May 20, 2015

Ms. Helen Donaldson
Planning and Development Department
City of Portland, Maine
389 Congress Street
Portland, Maine 04101-3509

**Subject: Century Tire Plaza – 195 Kennebec Street
Project ID# 2015-027
Review Comments Received May 7, 2015**

CENTURY TIRE SITE RENOVATION
 MARGINAL WAY, PORTLAND, MAINE
LANDSCAPE PLAN

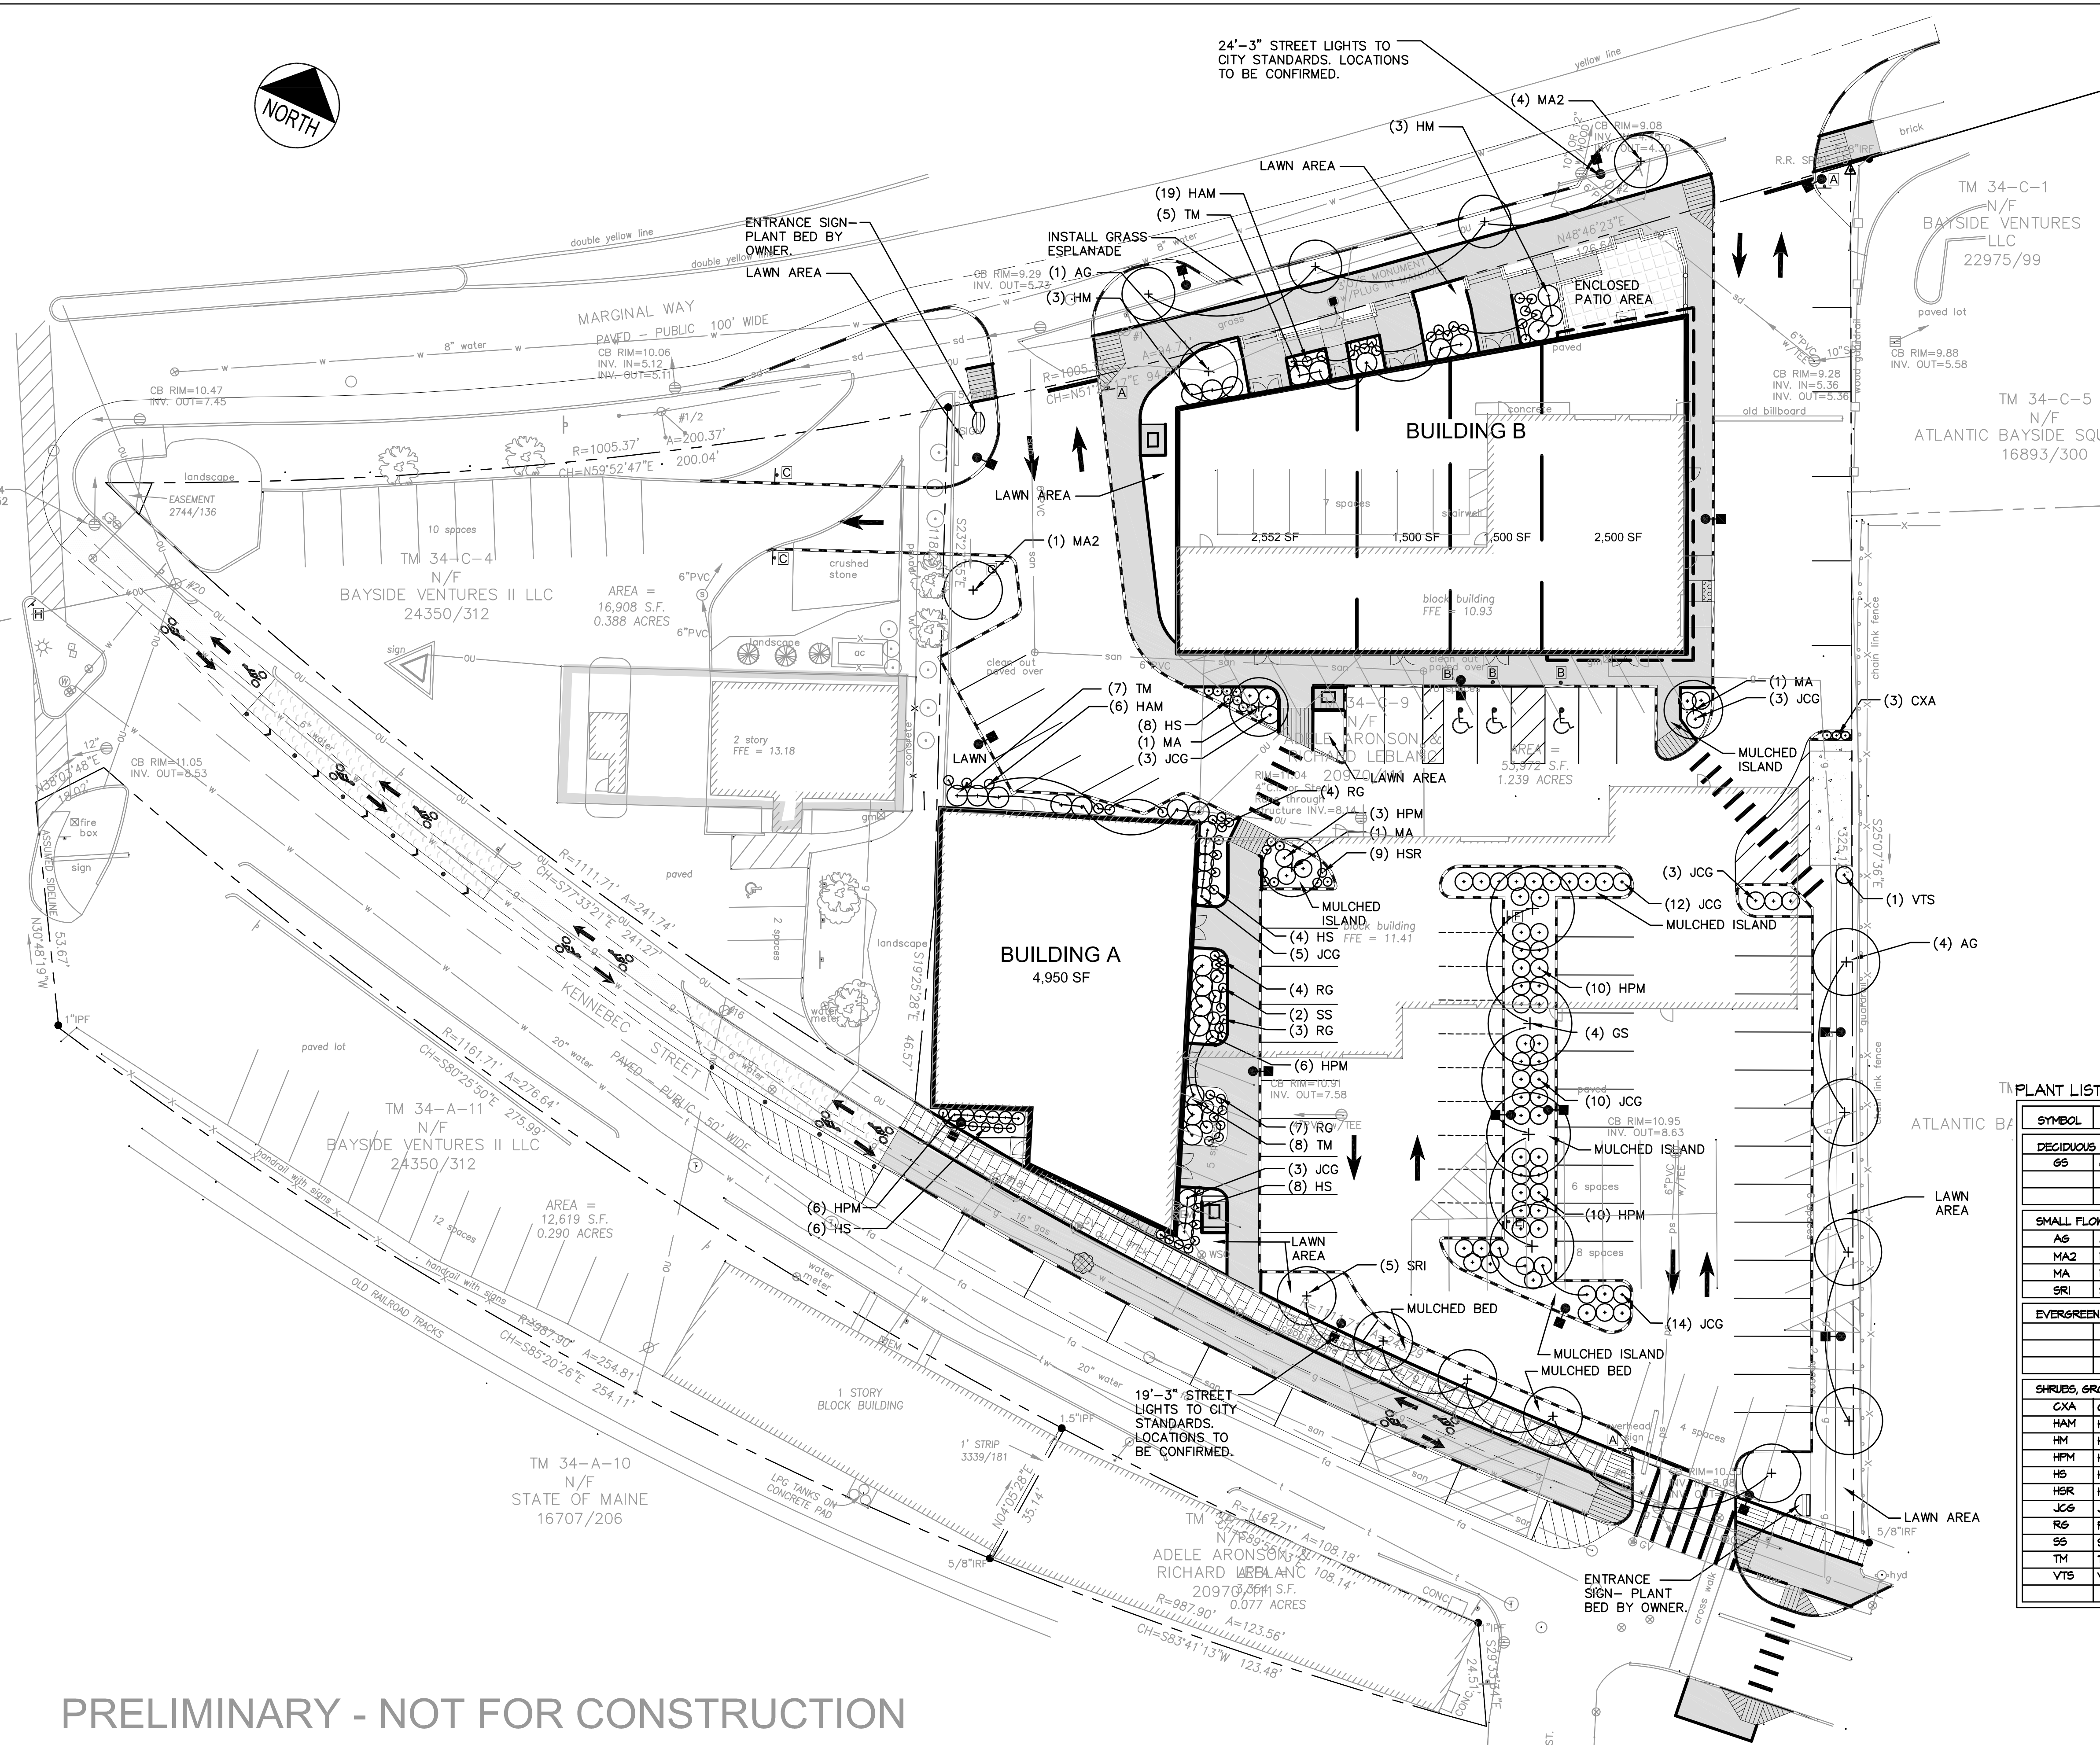
The snow storage note still appears on the landscape plan, as do references to Note #18 (which has been removed). Could you revise? Since you're planning to remove all snow from the site, could you add a note as such?

The note and references to the note have been eliminated from the revised Landscape Plan.
